PLANNING COMMISSION AGENDA

Title: Final Site Plan - Canyon Point In Centerville, 347 N 400 E - ADMINISTRATIVE DECISION

**PLANNING STAFF REPORT
AGENDA ITEM: 1**

Title: PUBLIC HEARING - Planned Development Overlay Amendment - Parrish Creek Business Park 1160 N 950 W - Tom Stuart Construction - LEGISLATIVE DECISION

AS.1

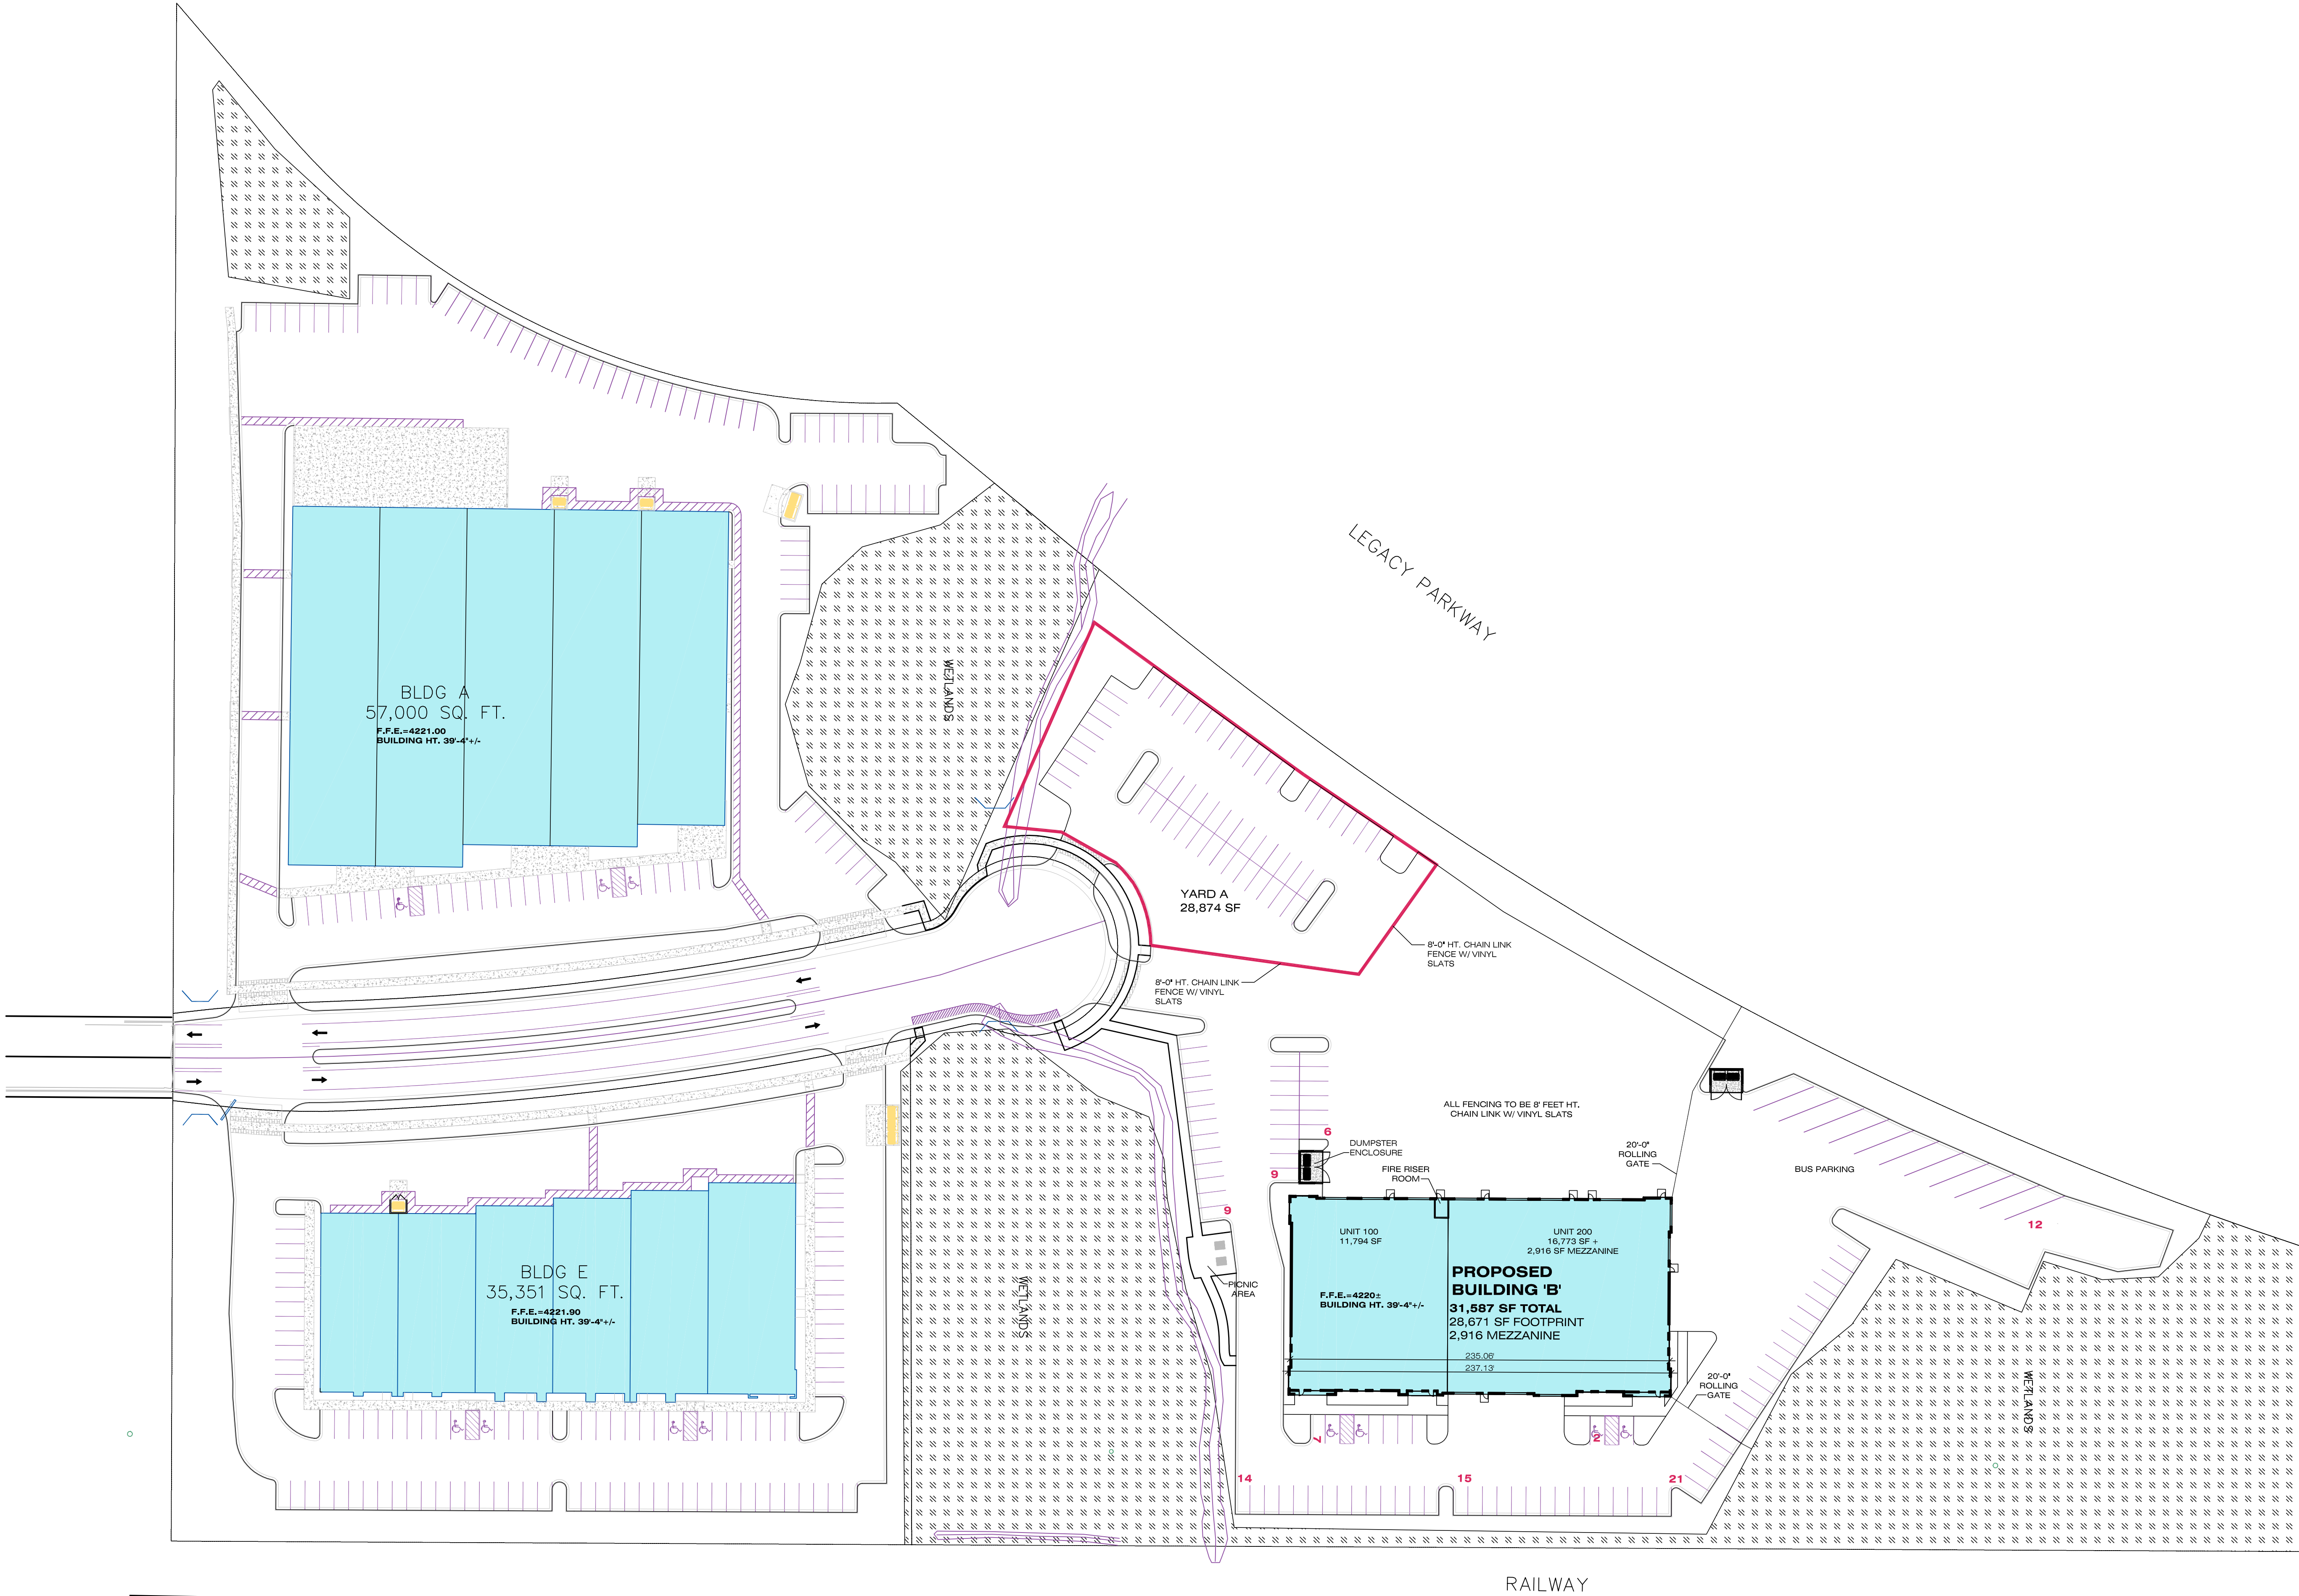
STAFF REVIEW AND COMMENTS: The original PDO Approval created four lots, with proposed buildings oriented to both Interstate 15 and Legacy Highway. The buildings and landscaping oriented to I-15 was a more formal business/office environment. While the buildings and landscaping oriented to Legacy Highway, specifically, the landscaping was less formal in design since it was facing the Shorelands Commerce Park. The Shorelands Commerce Park has an "enhanced upland theme." Such theme was to establish to create a distinct visual appeal using more natural colors, materials, and plantings compatible with the Legacy Highway theme for this western travel corridor and trail system.

For both schemes, the plantings would remain the same. However, Option 1 is to install screened fencing around the yard area. Option 2 is to install a berm some additional landscaping to buffer the screening fencing along the northerly edge of the yard area. If yard area is generally acceptable to the Commission, the staff recommends that Option 2 with the berm and additional landscaping be the chosen scheme. Nonetheless, staff

- a. *Sheet AS.1 – Site Plan, dated June 30, 2022*
 - b. *Sheet L-1 through L-4 – Landscaping Plan with berm [i.e. Parrish Creek Building B - Proposal 2], dated June 30, 2022.*
